Site Plan Review For Ypsilanti Township, Michigan

Applicant:	Crown Enterprises
Project Name:	Hercules Concrete Plant
Plan Date:	August 3, 2021
Location:	2555 State Street, Ypsilanti Twp
PID:	K-11-13-256-002
Zoning:	I-C, Industrial and Commercial Districts
Action Requested:	Final Site Plan Review.
Required Information:	As noted in this report.

RE: Hercules Concrete Plant 2555 State Street Site Plan Review #1

> Re: Preliminary (non-residential) Site Plan Review #1 Hercules Concrete Plant Charter Township of Ypsilanti (Plan Date: 08-03-2021)

CS1-100

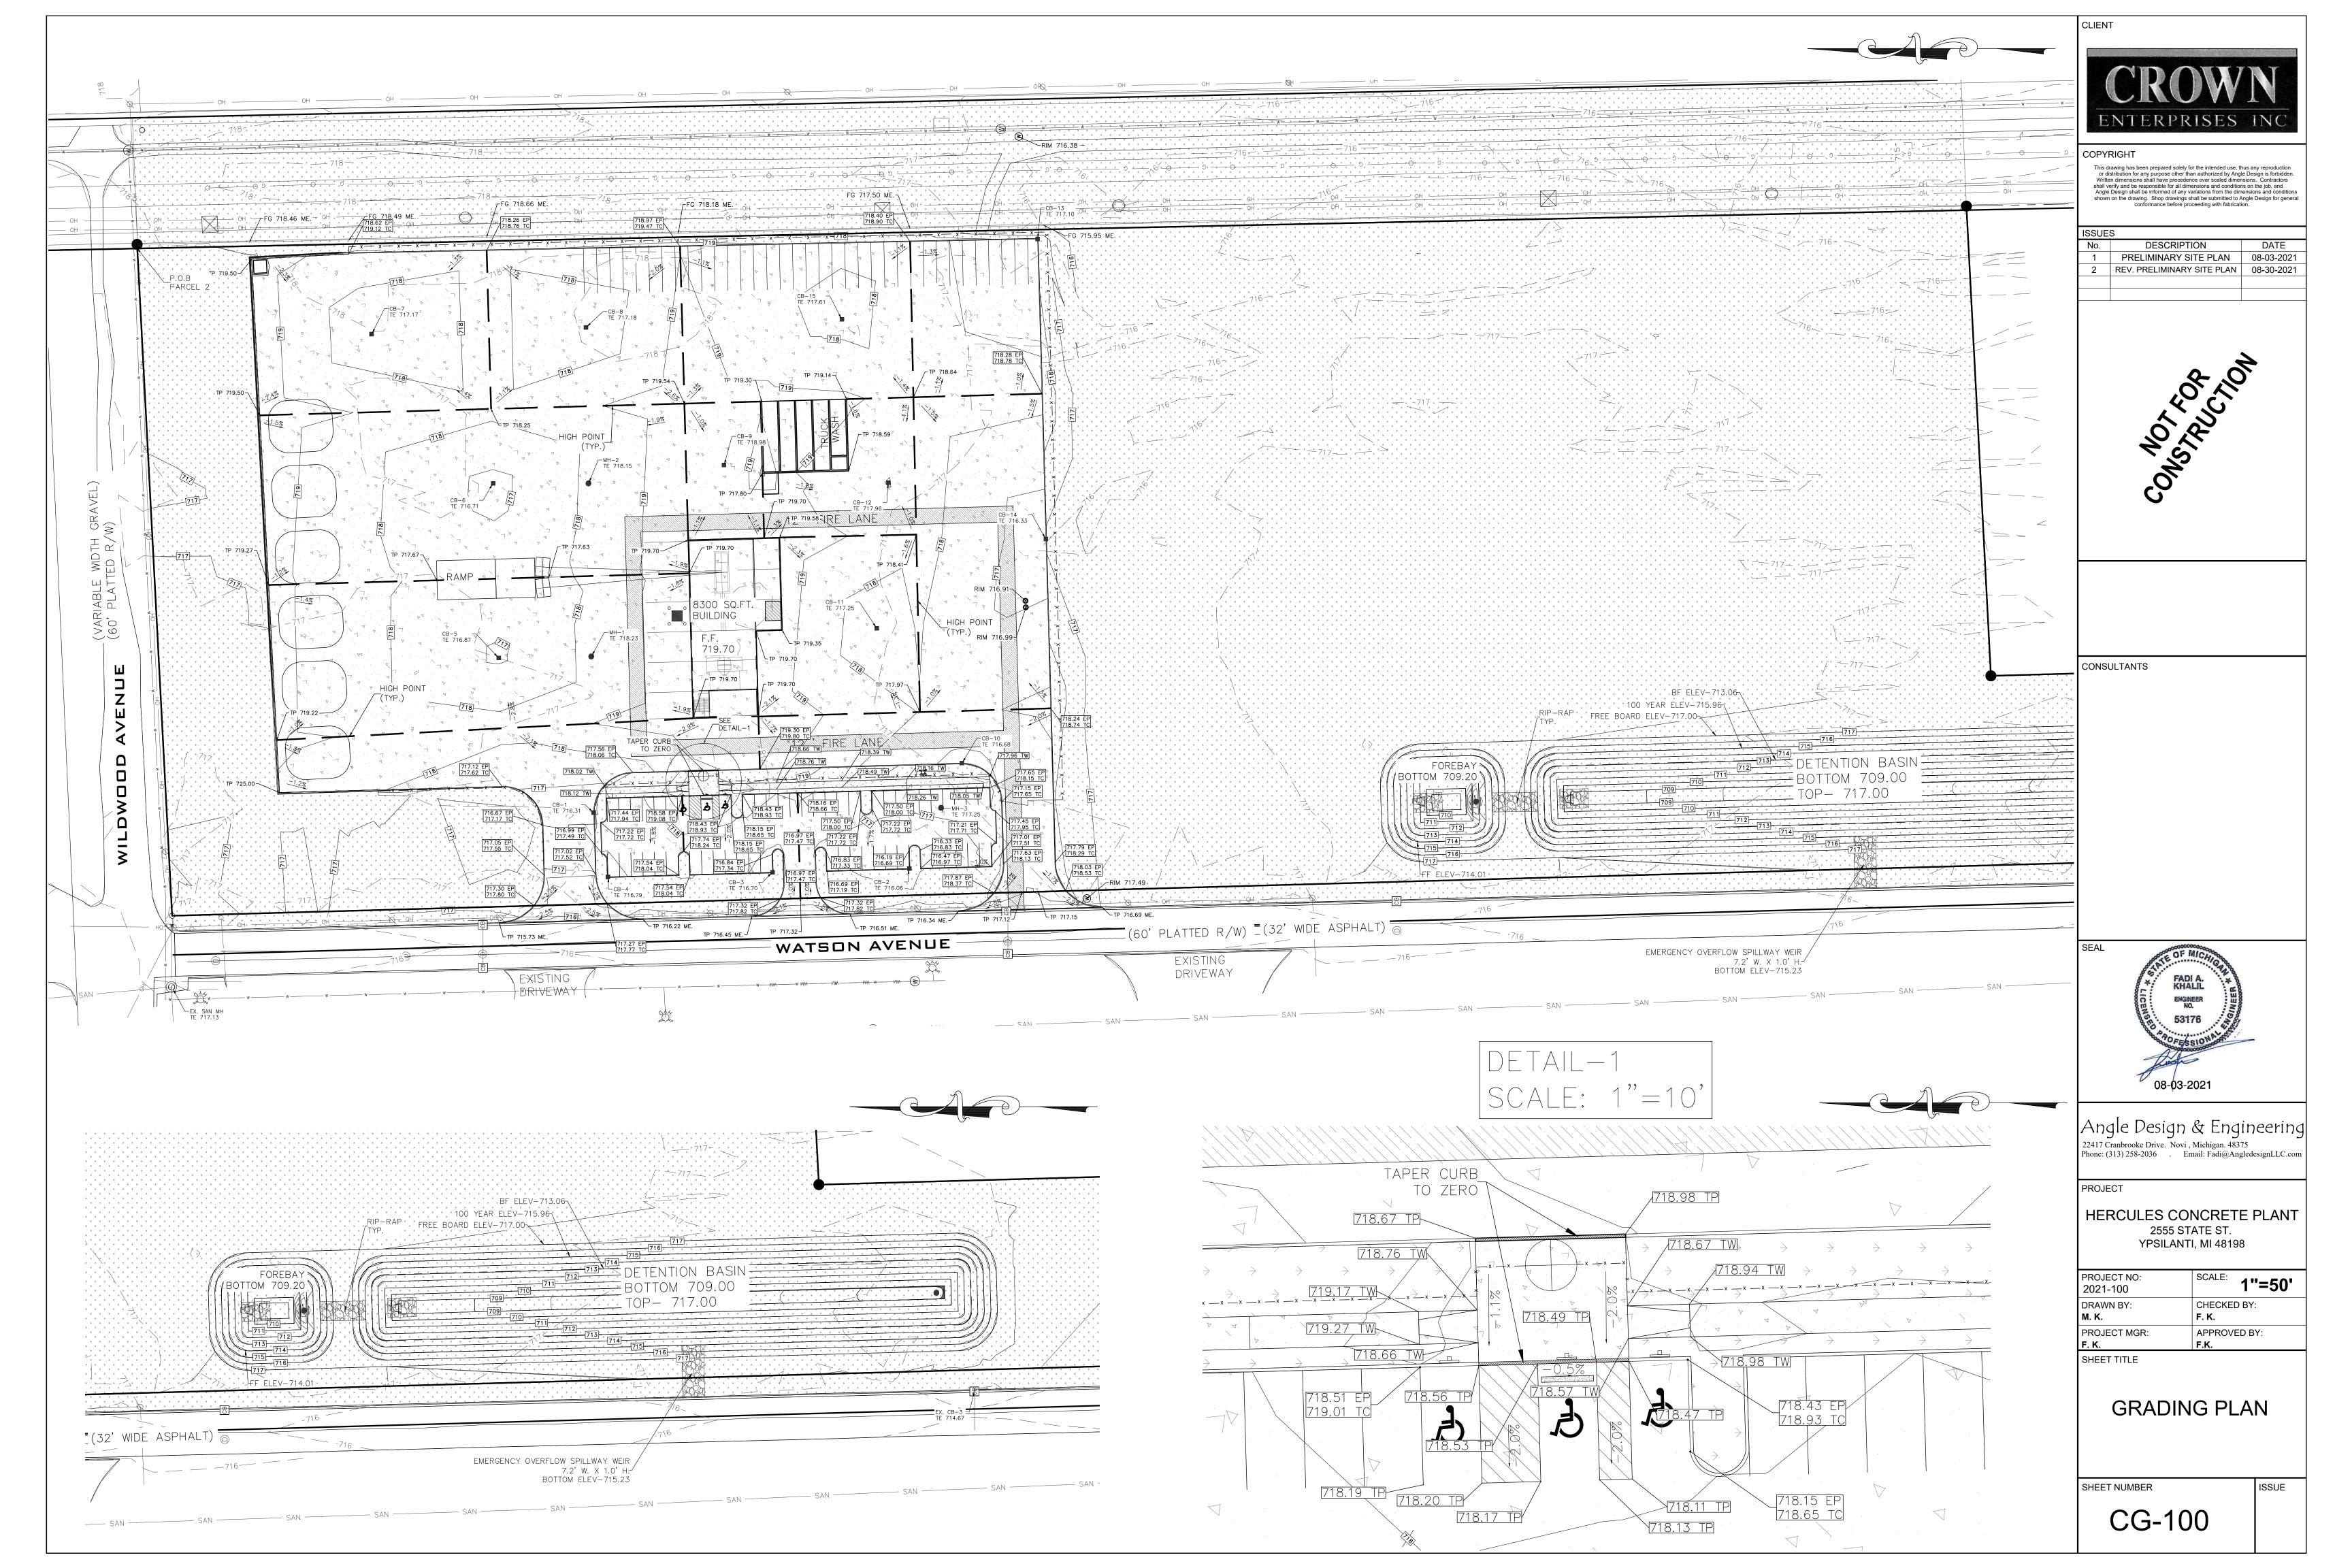
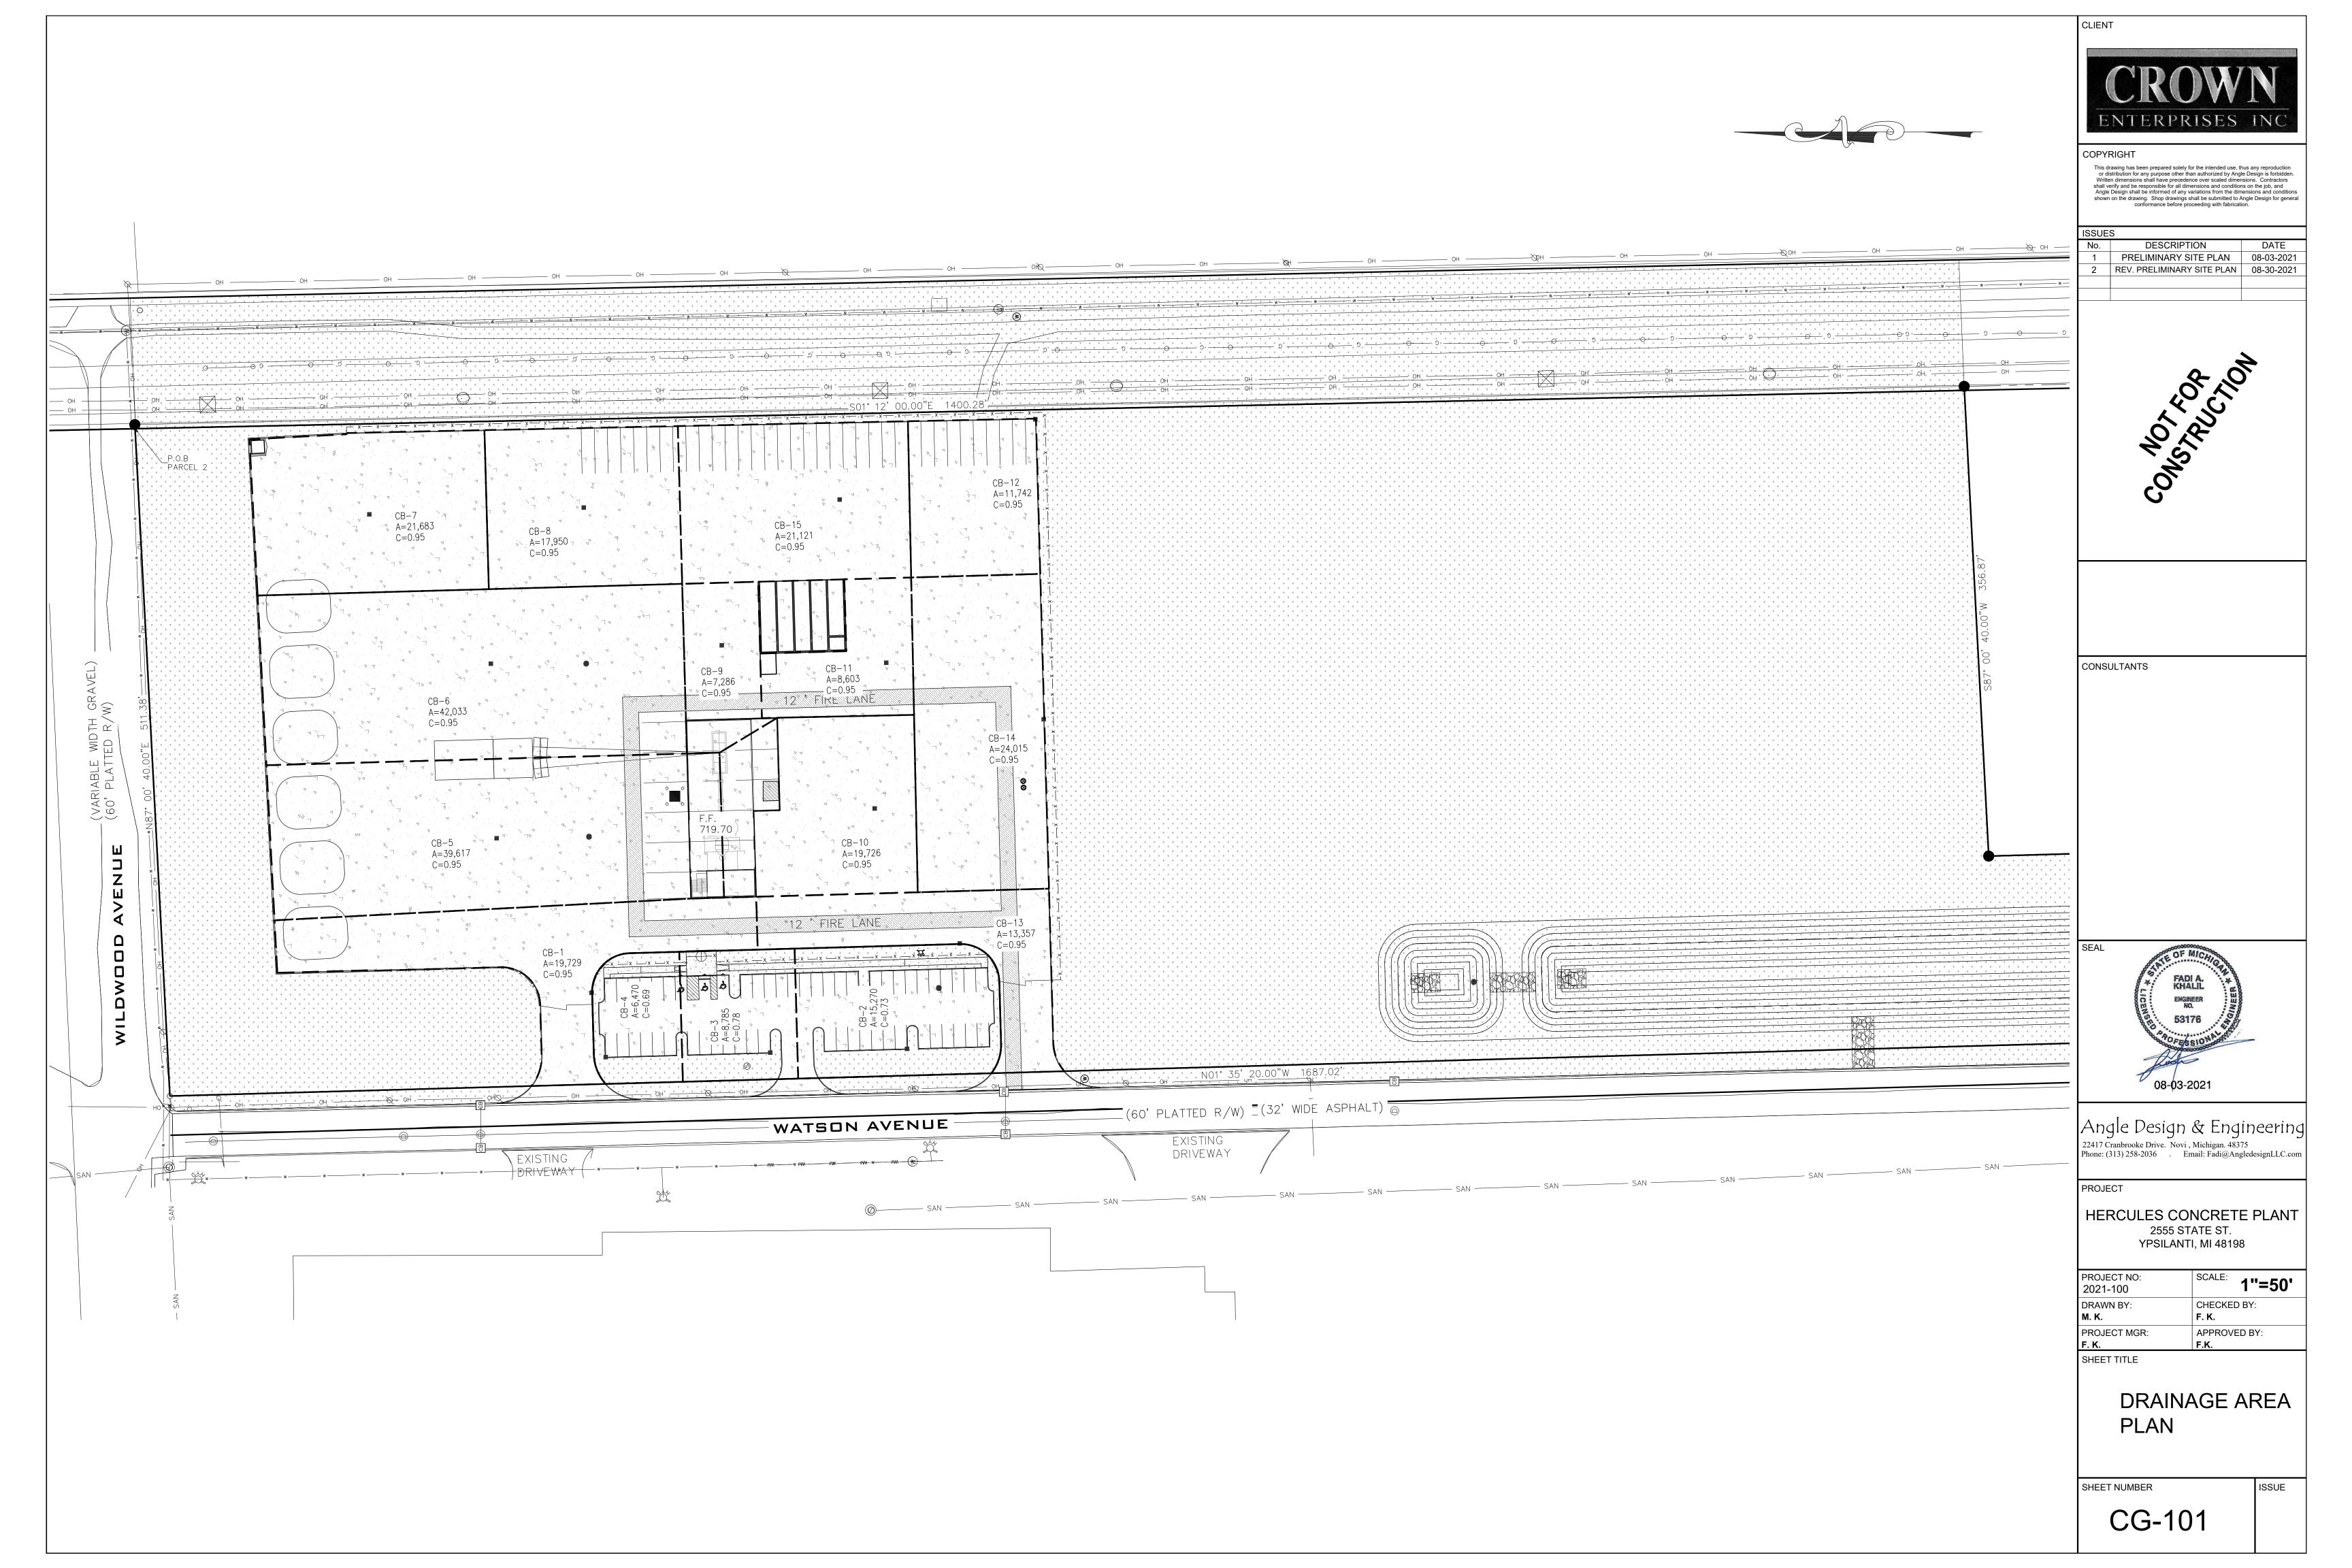
1. It currently appears that the proposed sanitary sewer locations on the utility plan sheet and the landscaping sheet differ. The applicant shall ensure there is no direct conflict between proposed trees and the proposed underground infrastructure and revise accordingly.

- 1. The proposed water main alignment is unacceptable. A marked-up copy of the proposed utility plan sheet showing an acceptable alignment is enclosed. In particular, an existing gate valve just north of the end of the existing 8" diameter water main on Watson Avenue eliminates the need for a tapping sleeve and valve and the connection to the existing 24" diameter water main parallel to the east property line needs to be made south of the existing gate valve.

- 2. The utility plan shows both a 2" diameter water service and a 4" diameter water service to the proposed building. It is unclear why two separate water services are necessary.

- 3. The upstream terminus of the existing sanitary sewer on Watson Avenue is located just northwest of the existing 8" diameter gate valve noted it item 1 above. This manhole may provide a more cost effective connection location for the wastewater discharge from the proposed facility.
